# Staff Report

To: Salt Lake City Historic Landmark Commission  
From: Katia Pace, Principal Planner (801)-535-6354, [katia.pace@slcgov.com](mailto:katia.pace@slcgov.com)  
Date: September 1, 2022  
Re: PLNHLC2022-00665 – Minor Alterations for an addition and chimney removal

## Minor Alteration

**DEMOLITION PLAN**  
SCALE: 1/2"=1'-0"  
A AD1.1

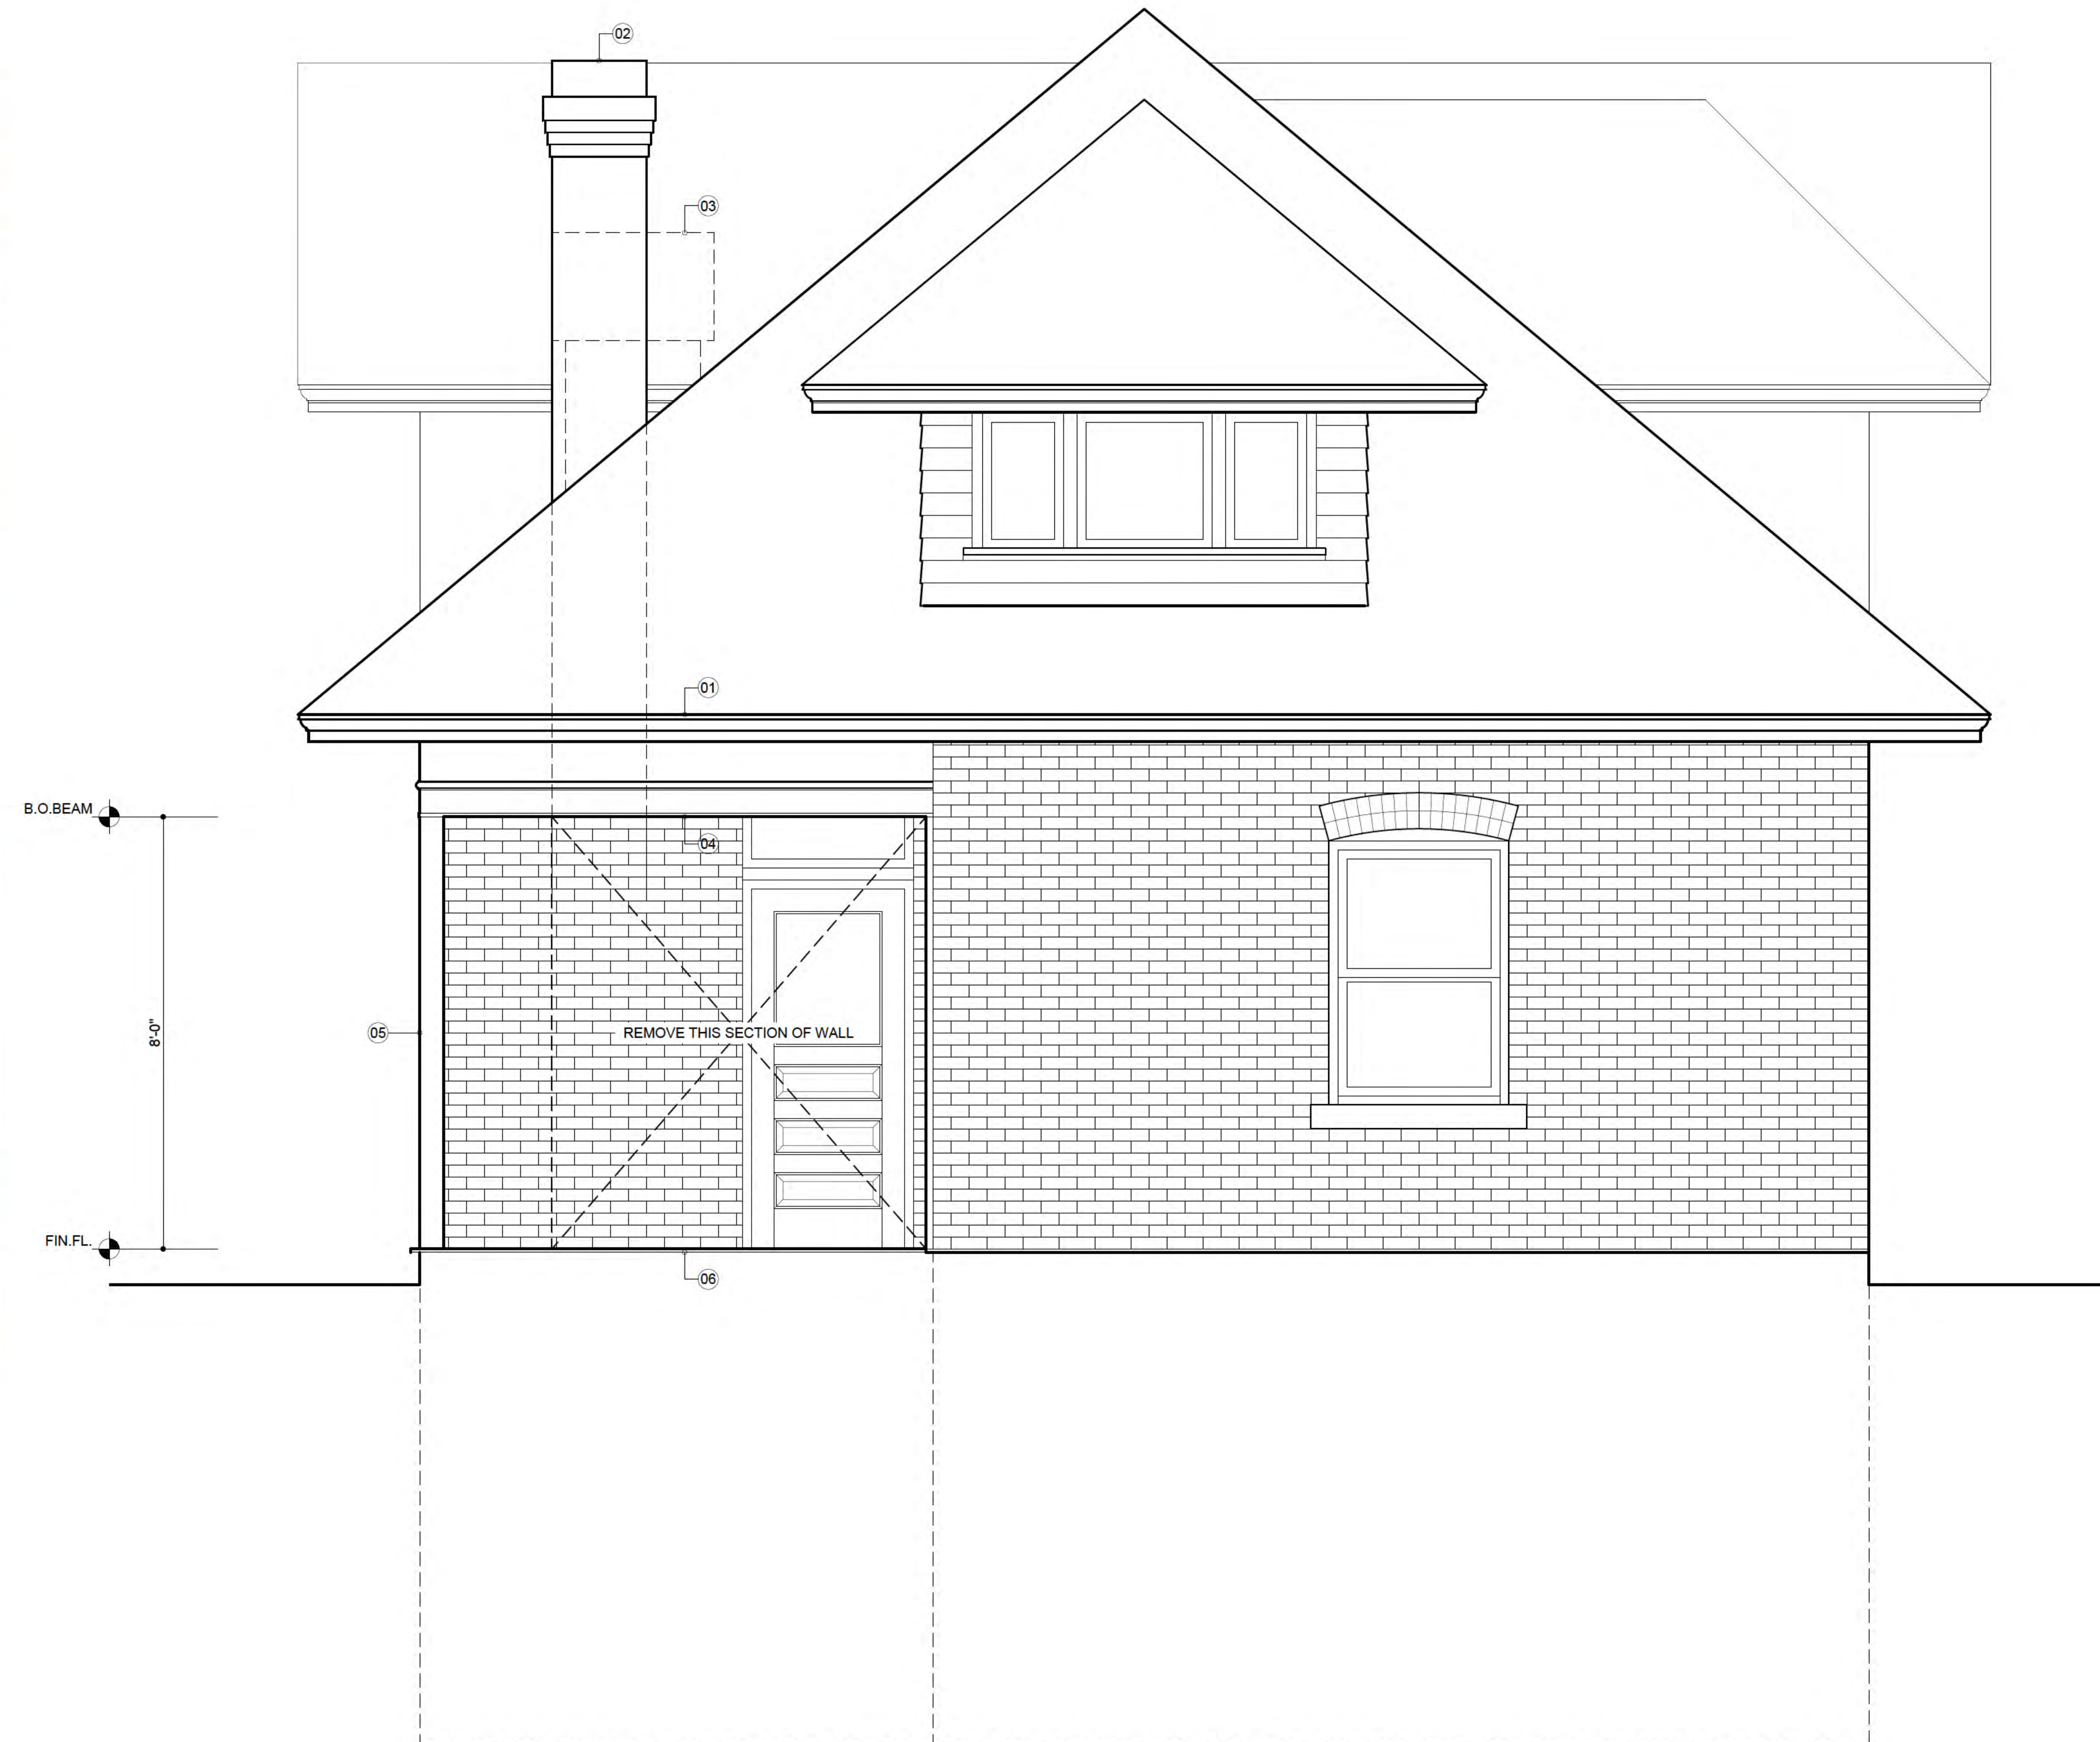
The applicant is seeking permission to remove the rear chimney to expand the kitchen.

The chimney is a character defining feature of the subject property. According to the Residential Design Guidelines (Chapter 7, Roofs) for historic properties, “Chimneys and dormers can be major character defining features of the roofscape and are often designed to great effect to crown and embellish the architectural composition. In many instances they combine functionality with great decorative impact.” (Part II, 7:1) The character of historical roof should be preserved, including its form, features, and materials whenever feasible. Historic chimneys and their details should be retained.” (Part II, 7.2) Staff finds that removing the chimney conflicts with applicable design guidelines.

According to a structural engineer (see Attachment D) hired by the property owner, “unreinforced brick masonry chimneys represent a serious seismic threat to the safety of residents and the general public in our city. They are vulnerable to even moderate earthquake forces as documented from California and other areas. The large mass (weight) of the brick and mortar extending above the roof will fall, perhaps in one large piece onto and through the roof or to the ground crushing what or whomever is in the way. The probability of such an event is relatively high.” Staff’s suggestion is to reinforce the chimney.

Based on the information in this staff report, Planning Staff recommends that the Historic Landmark Commission approve the Certificate of Appropriateness (CoA) for the proposed addition and deny the CoA for the proposed removal of the chimney.

If the Historic Landmark Commission agrees with Staff’s recommendation and approves the rear addition as proposed, but denies the removal of the chimney, the applicant would need to revise the request to reinforce the chimney and meet the standards of approval before a CoA could be issued and building permits could be obtained.

1 DEMO ELEVATION - SOUTH  
AD1.3 SCALE: 1/2"=1'-0"

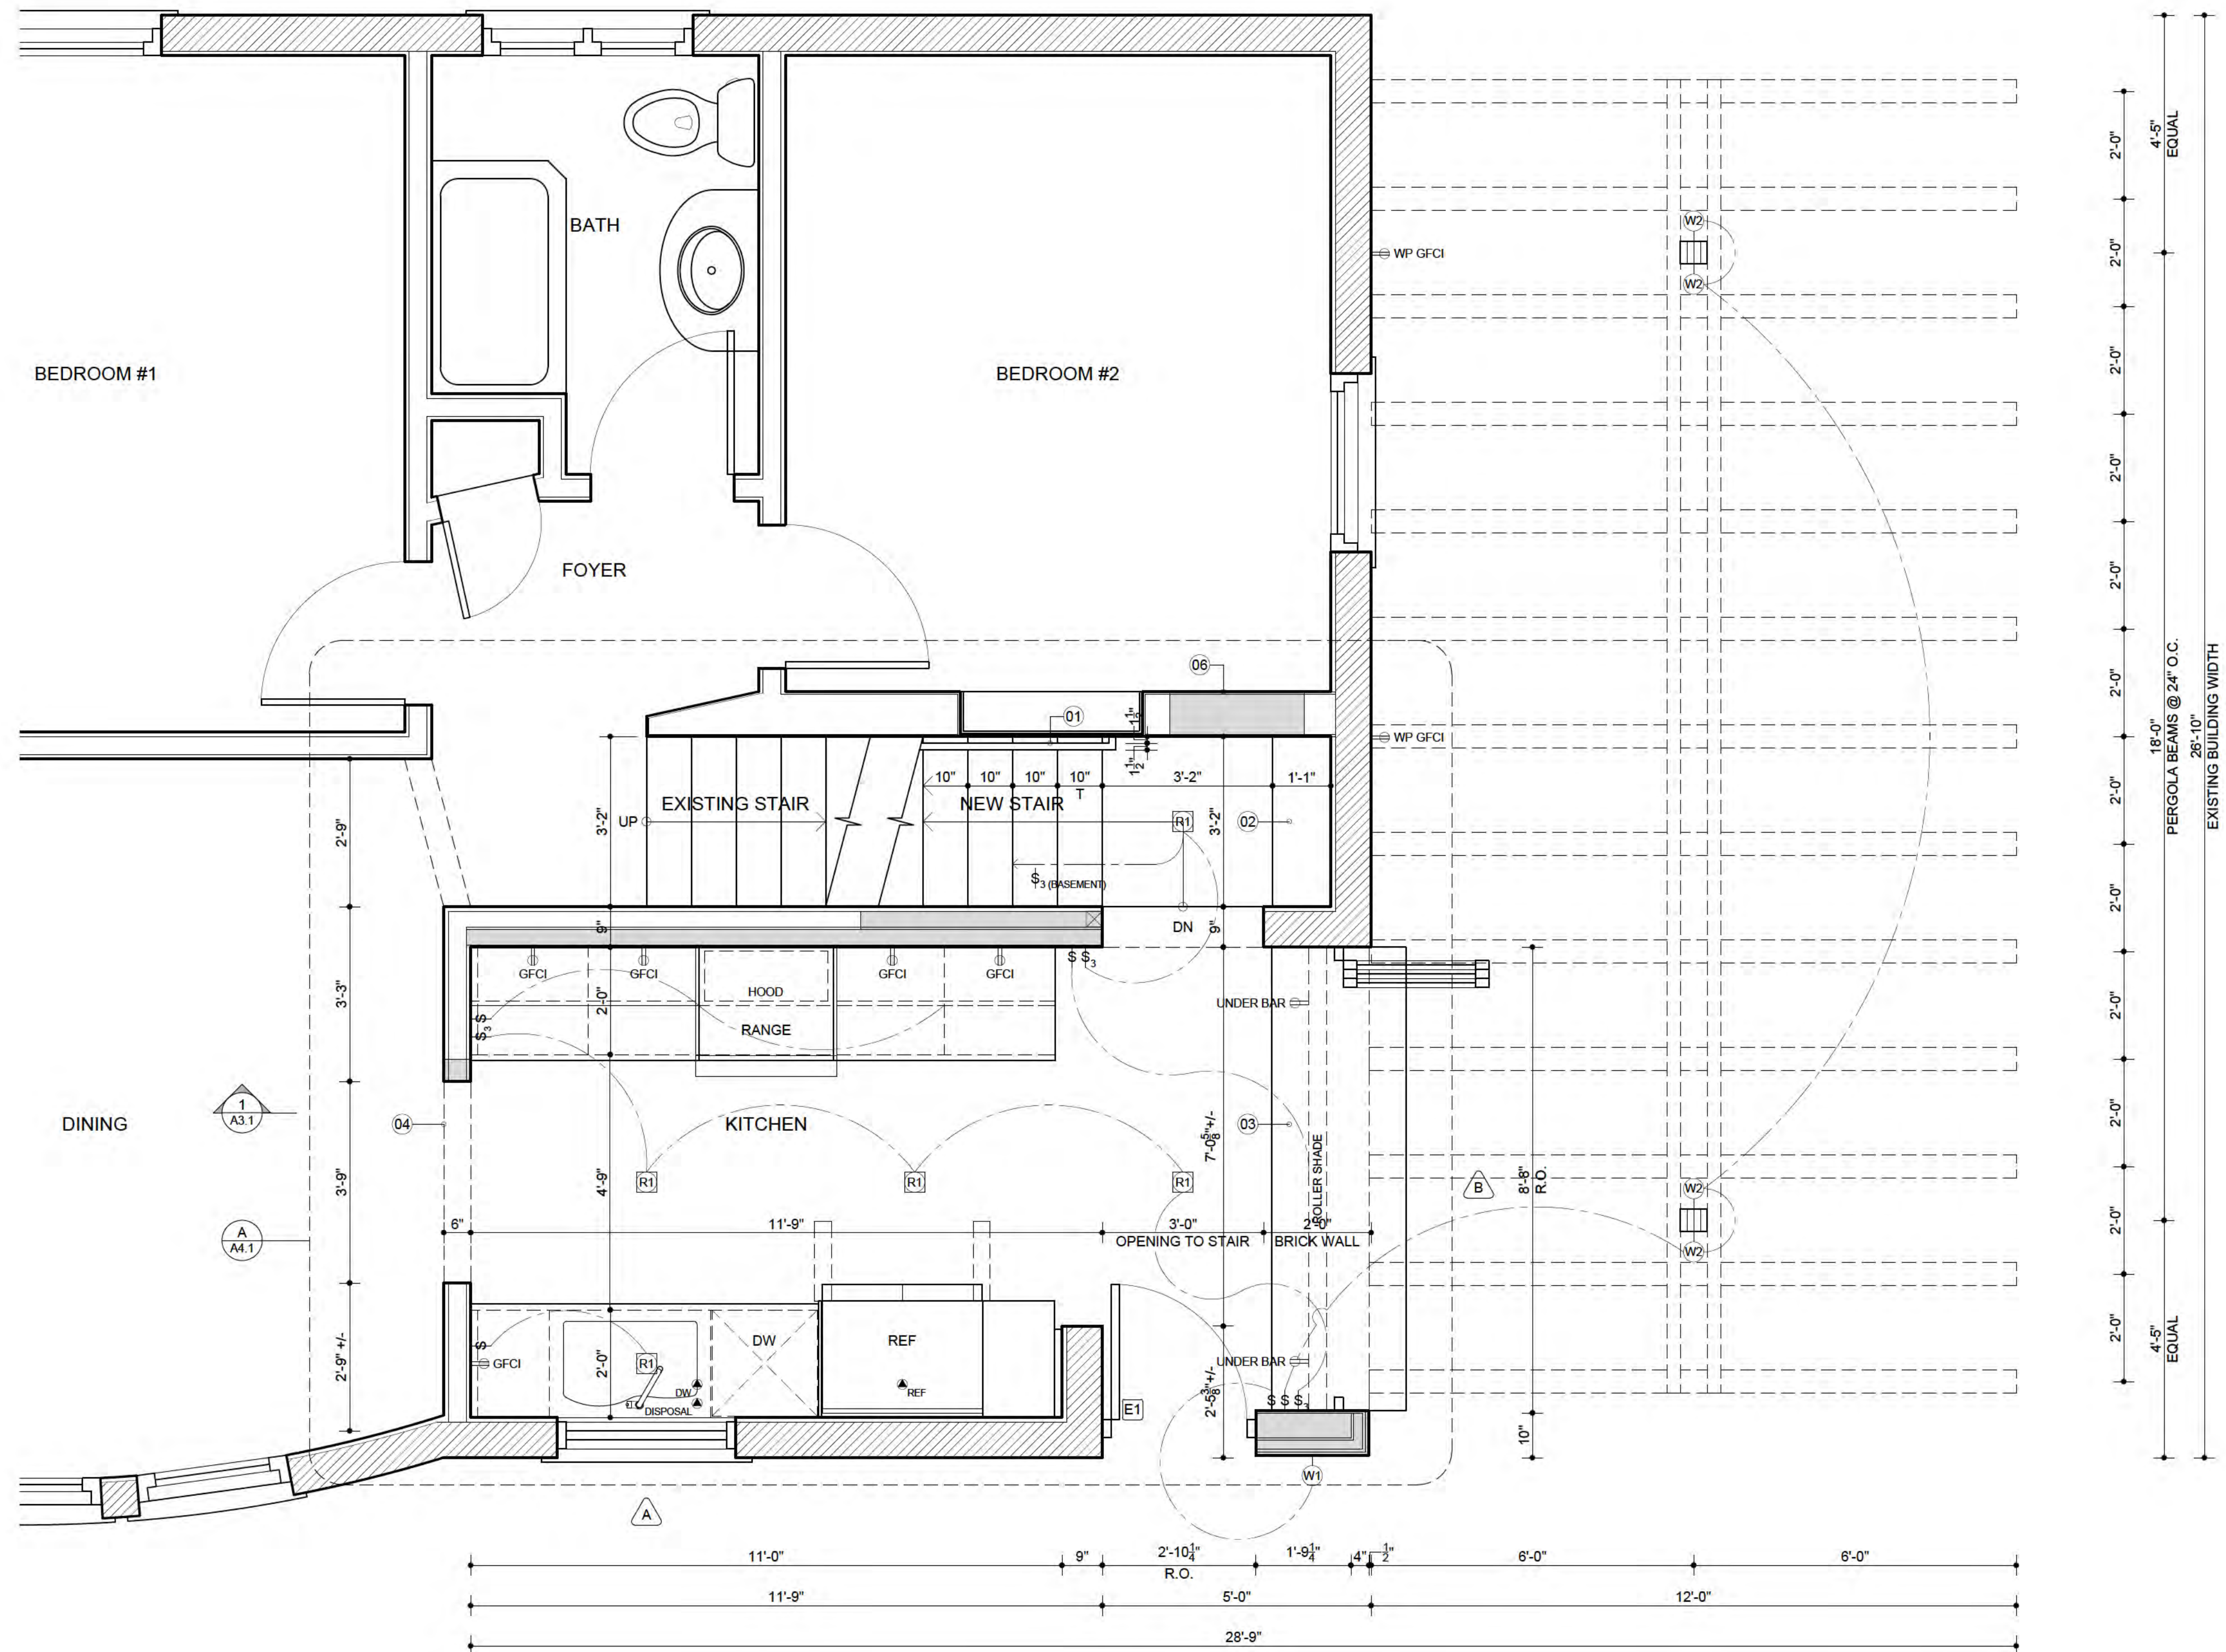
The applicant is requesting to remove an existing double hung window and replace it with a shorter window to allow for a new kitchen sink on the interior. Windows, like the chimney, are a character defining feature. However, the Residential Design Guidelines are more specific in pointing it out that preservation of original windows is especially important on primary facades, and “greater flexibility in installing new windows may be appropriate on rear walls or areas not visible from the public way.”

In this case the proposed window to be replaced would be on the rear of the south elevation, and it will be shielded by an existing 6 ft. wood fence. Making it not visible from the public way.

Image 3: Close up view from east sidewalk

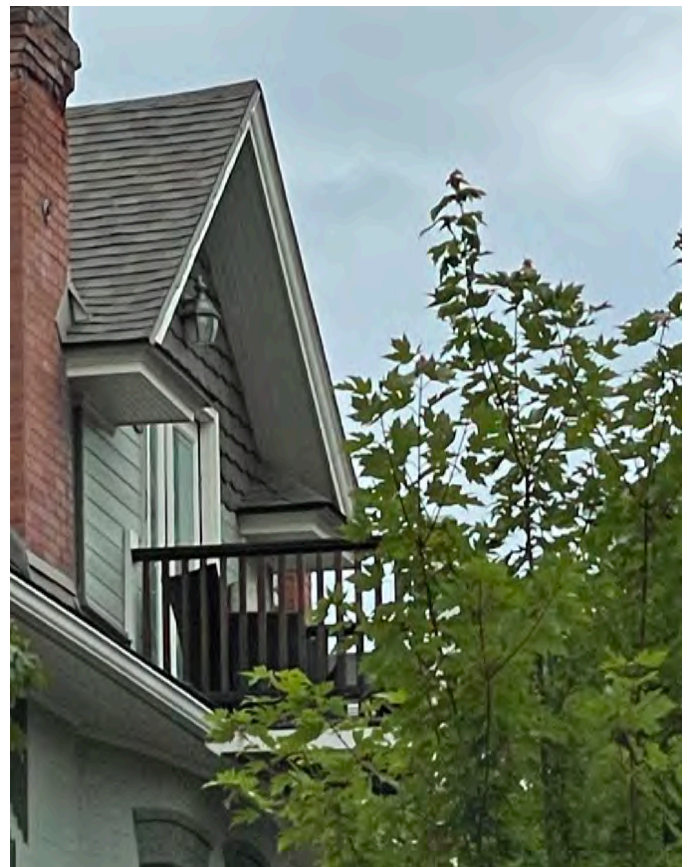
The applicant argues (see Attachment D) that the chimney has little visibility from the street. Across the street, on the west sidewalk, a pedestrian would have a glimpse of the top of the chimney, but this is a very limited view with a narrow cone of vision. U Street is a one-way street, and a passenger on a vehicle would not perceive the presence of the rear chimney. However, a Google Maps image from Streetview shows a picture of the chimney.

Lastly, we have taken the time to photograph the home from different positions to show how little the chimney is visible from the street. One of the most revealing comparisons is the vast difference between the east side of the street – the side walk adjacent to Rickie's property and across the street. It is very clear that there is zero visibility of the chimney from the east sidewalk. Across the street, on the west sidewalk, you do catch a glimpse of the top of the chimney, but this is a very limited view with narrow cone of vision. For instance, driving on this one-way street, a passerby would never perceive the presence of the rear chimney. It's simply not possible. We are currently assuming that the city has rendered their interpretation from a google image, which is taken from a top of a car and a singular point of view, to be the definitive piece of information. We encourage you to visit the property in person to decide for yourself.
